**STATE PROJECT NO.: 2020-148**  
**PIERCE COLLEGE PUYALLUP**  
**NEW STEM BUILDING**  
 1601 39th AVE SE  
 Puyallup, WA 98374

Revisions		
#	Date	Description
1	08/19/2022	PERMIT RESUBMITTAL

TESC AND DEMOLITION PLAN

## 3 SILT FENCE

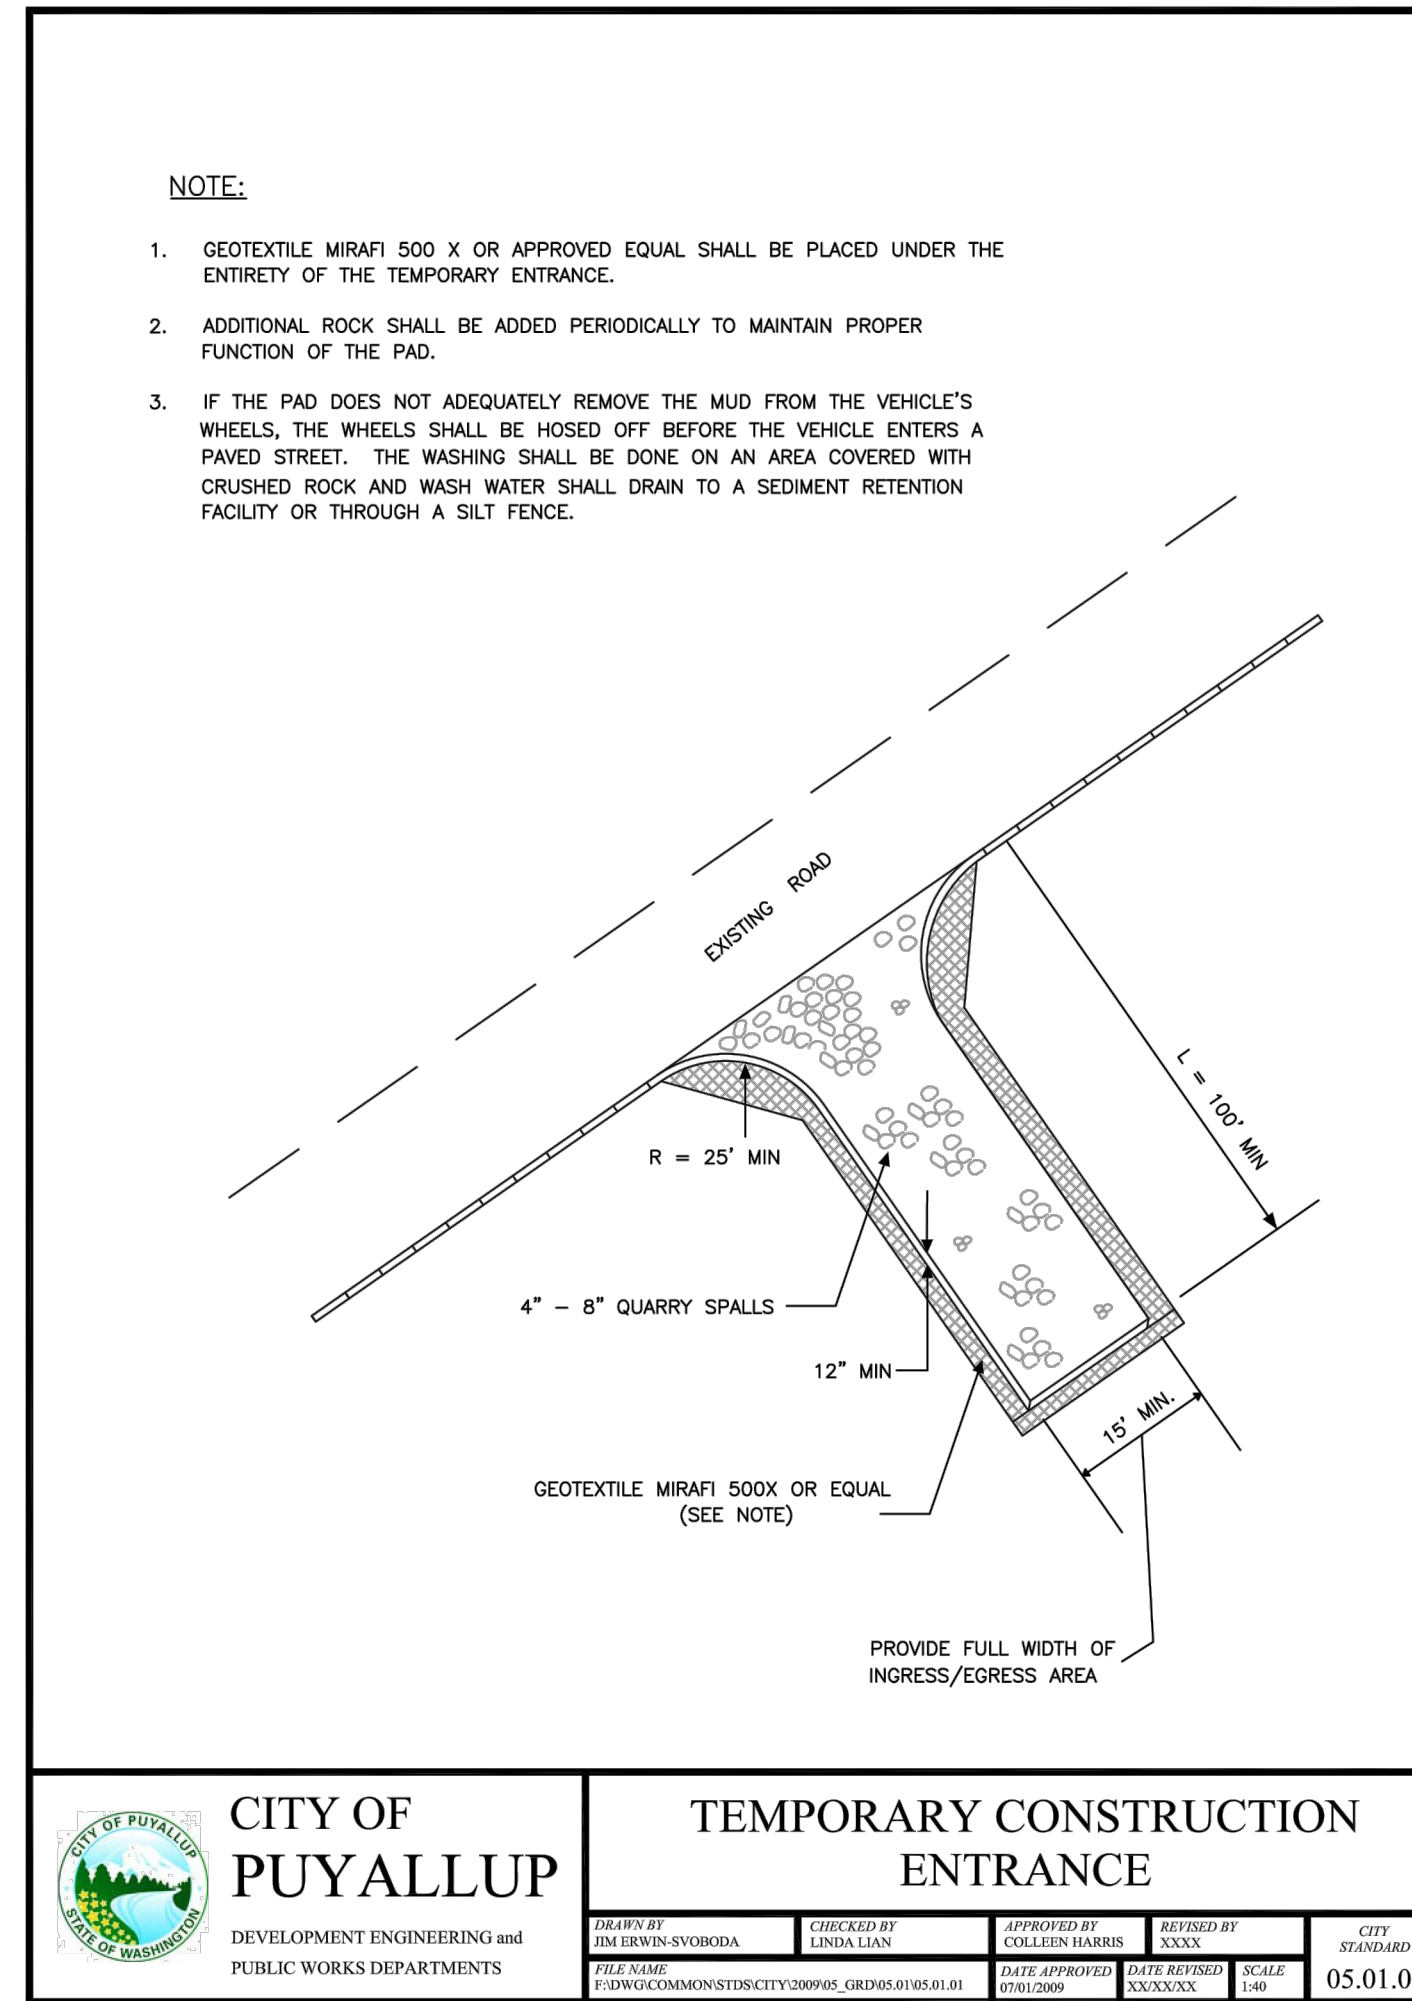
Replace with COP Standard detail 02.03.02 for siltation fence, [TESC, C2.4]
